## VILLA D'ESTE JSP17-52 with Rezoning 18.718

### VILLA D'ESTE JSP 17-52 AND ZONING MAP AMENDMENT 18.718

**3<sup>rd</sup> Revised PRO Concept Plan** for rezoning Request from RA (Residential Acreage) To R-1 (One-Family Residential) with Planned Rezoning Overlay (PRO)

**OVERALL PLAN**

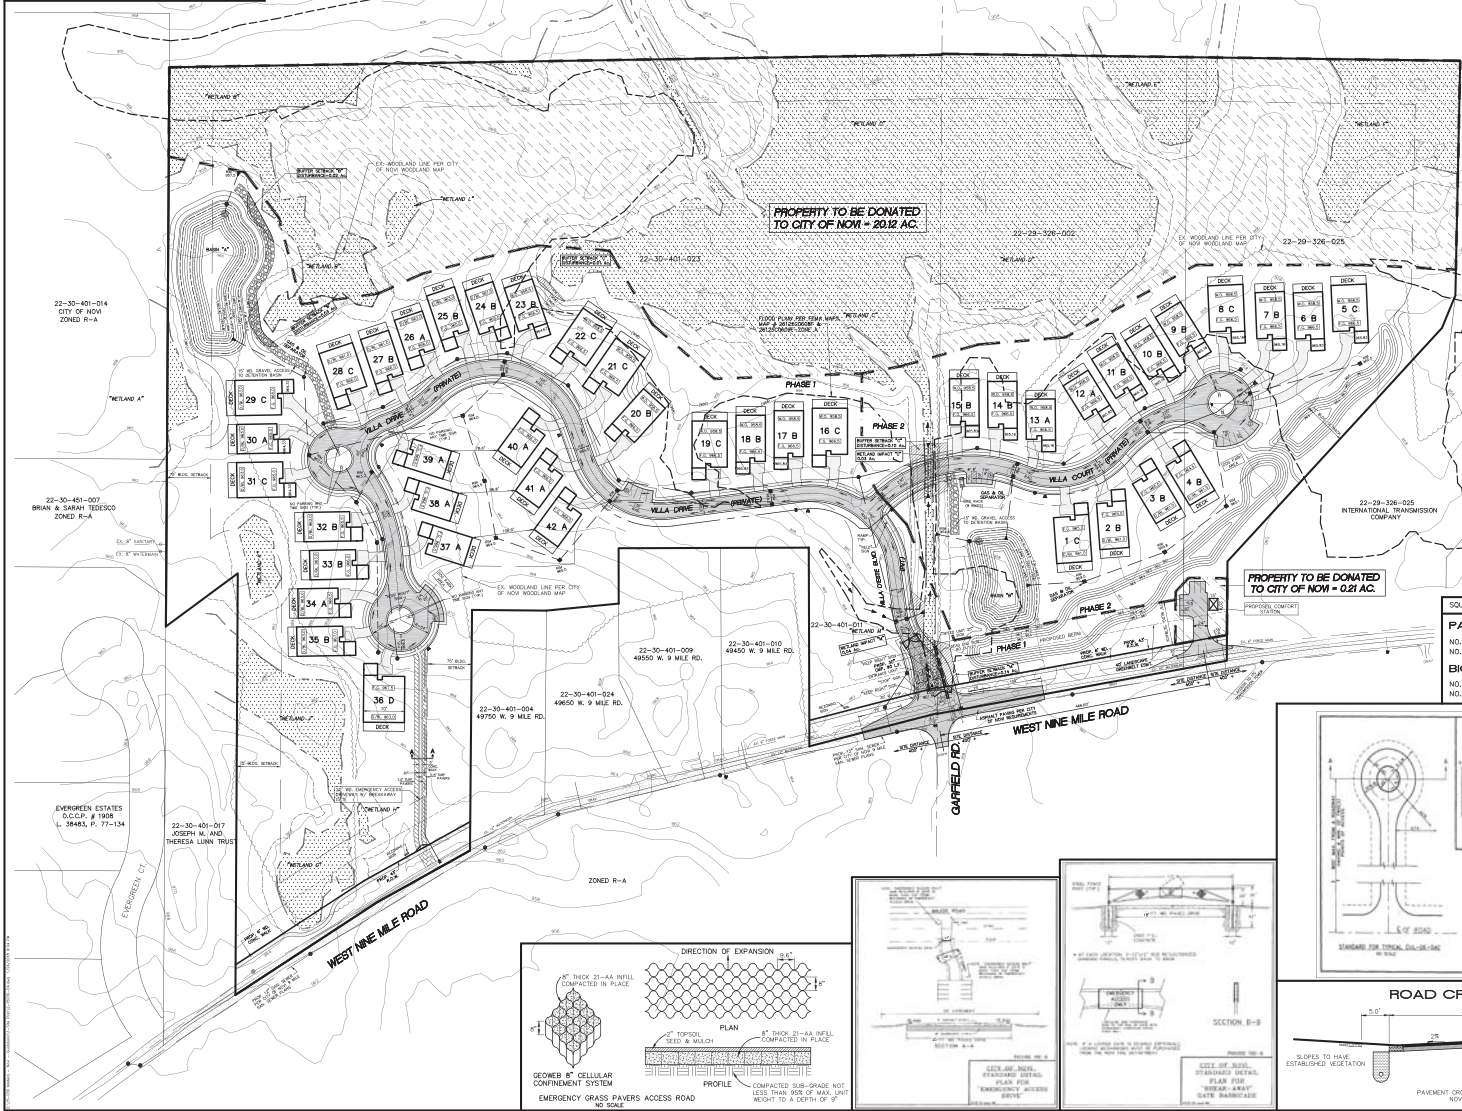
The following table summarizes the proposed wetland impacts as listed on the *Overall Plan* (Sheet 2):

It should be noted that the Wetland Impact table on the Plan indicates the impact area to the Wetland C buffer is 0.110-acre. The note in the plan view (i.e., Sheet 2) indicates the impact area as 0.01-acre. This quantity shall be clarified on the Plan.

***This comment still applies; however the applicant has made modifications to the Plan that have decreased the overall amount of proposed wetland buffer impacts. It should be noted that the Wetland Impact table on the Plan indicates the impact area to the Wetland C buffer (between proposed Buildings 22 & 23) is 0.110-acre. The note in the plan view (i.e., Sheet 2) indicates the impact area as 0.01-acre. This quantity shall be clarified on the Plan.***

sheet title:  
**WOODLAND STUDY PLAN**

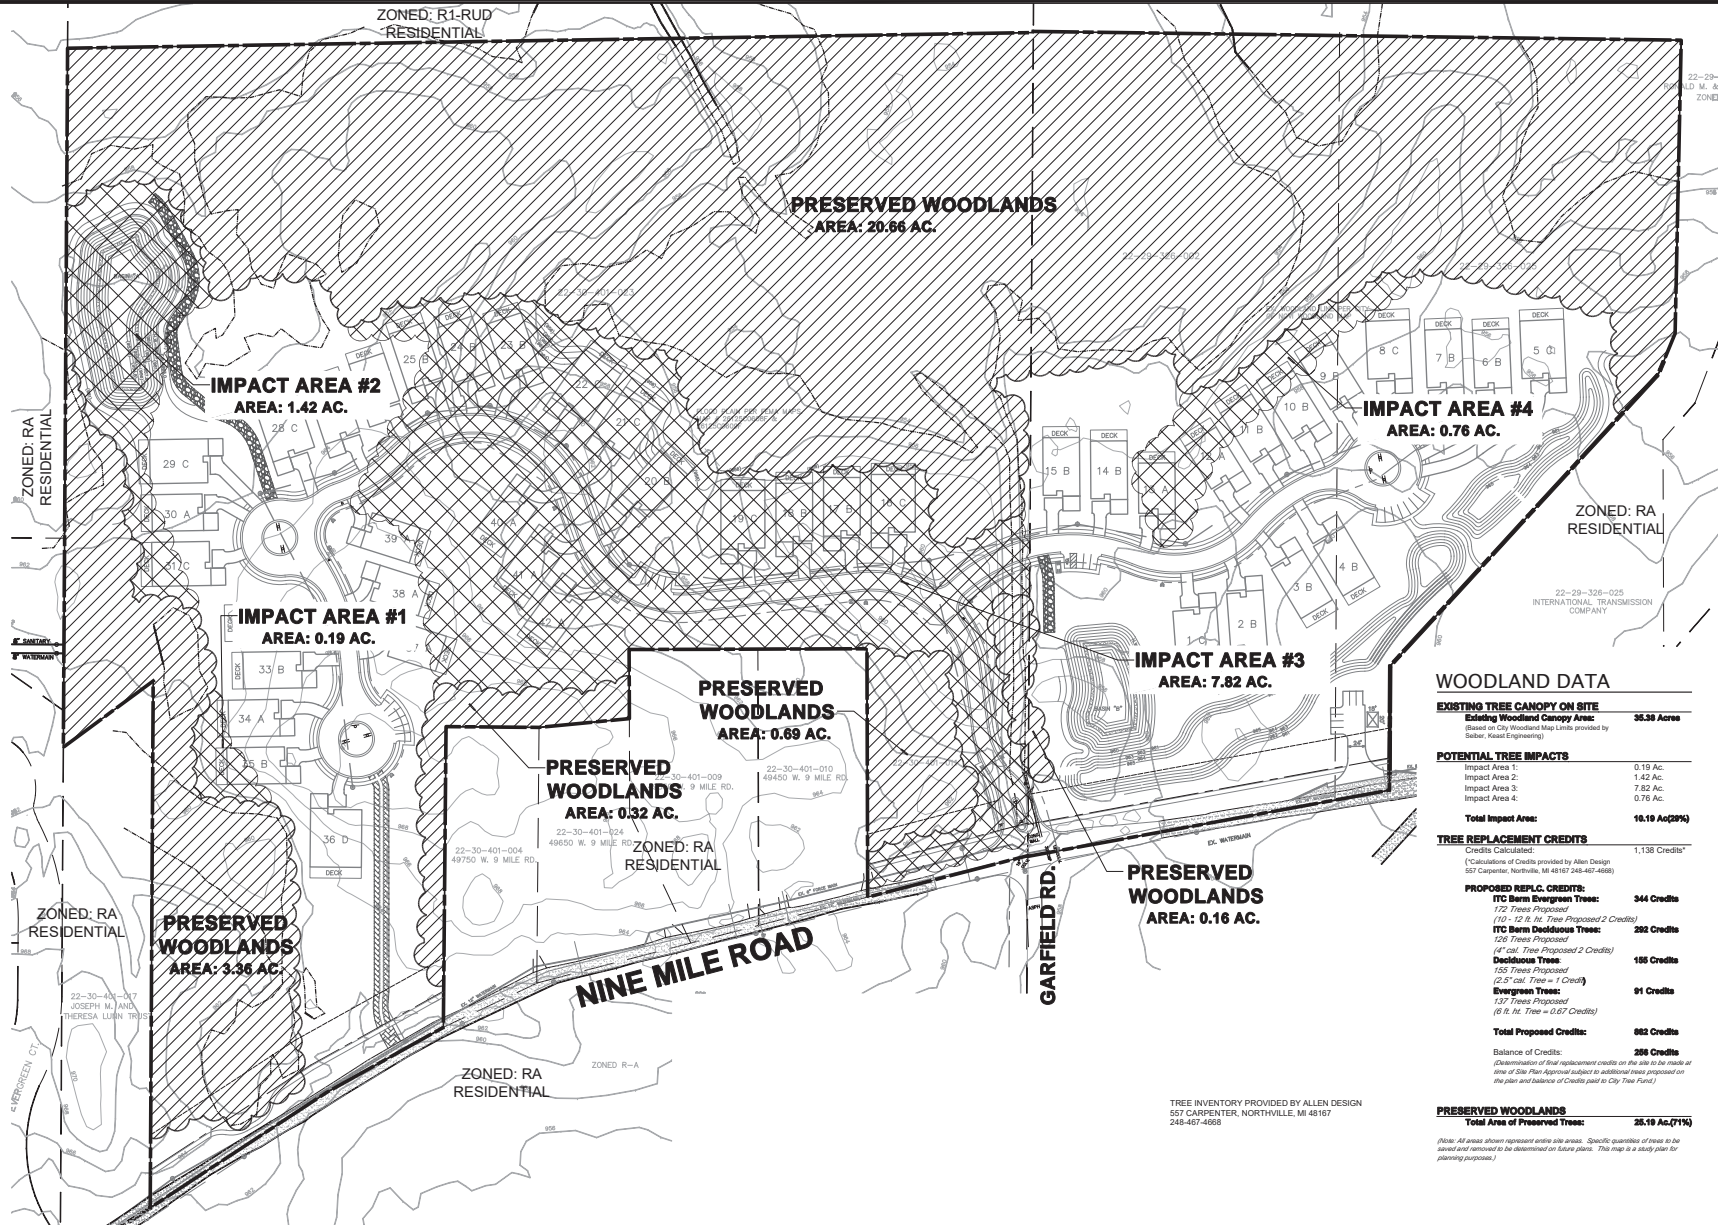
3. **Woodland Impacts:** The Planning Commission asked the applicant to provide a comparable plan to compare the impacts to woodlands and wetlands. The applicant has provided sheet WP-1. The plan indicates a total of 35.38 acres. Of which, the concept plan proposes to impact 10.19 acres (about 29 percent). 1,138 credits would be required based on preliminary calculations and the applicant notes. The impact area calculated is based on certain approximations. Staff is unable to determine exact removal or replacement counts.

A Woodland Study Plan (Sheet WP-1) has been included with the Plan that indicates the approximate location of the Regulated Woodland boundary as indicated on the City's Regulated Woodland Map with respect to the proposed limits of disturbance for the development. The Woodland Study Plan notes that 35.38 acres of the 51 acre development site is existing tree canopy based on the City's Regulated Woodlands Map. As such, the current Plan notes that 10.51 acres of the 35.38 acres (30 %) of the Regulated Woodlands located on-site will be impacted. Proposed impacts to individual trees have not been described/quantified. The Plan does not currently appear to indicate the proposed sizes and species of the proposed onsite Woodland Replacement Trees. The Plan should clearly indicate the locations, sizes, species and quantities of all woodland replacement trees to be planted. **Woodland review could not complete a comprehensive review due to deficiencies in the plan. The applicant is encouraged to further modify the layout to minimize impacts to regulated woodlands and quality/specimen trees.** Please refer to the woodland review letter or additional information requested.

***This comment still applies. The Woodland Study Plan (Sheet WP-1) notes that part of the 882 Woodland Replacement Credits provided are proposed through the planting of 10' to 12' tall evergreen trees at 2 credits per tree and 4" caliper deciduous trees at 2 credits per tree along the existing ITC corridor. Again, the "upsizing" of Woodland Replacement trees for additional Woodland Replacement credit is not supported by the City of Novi.***
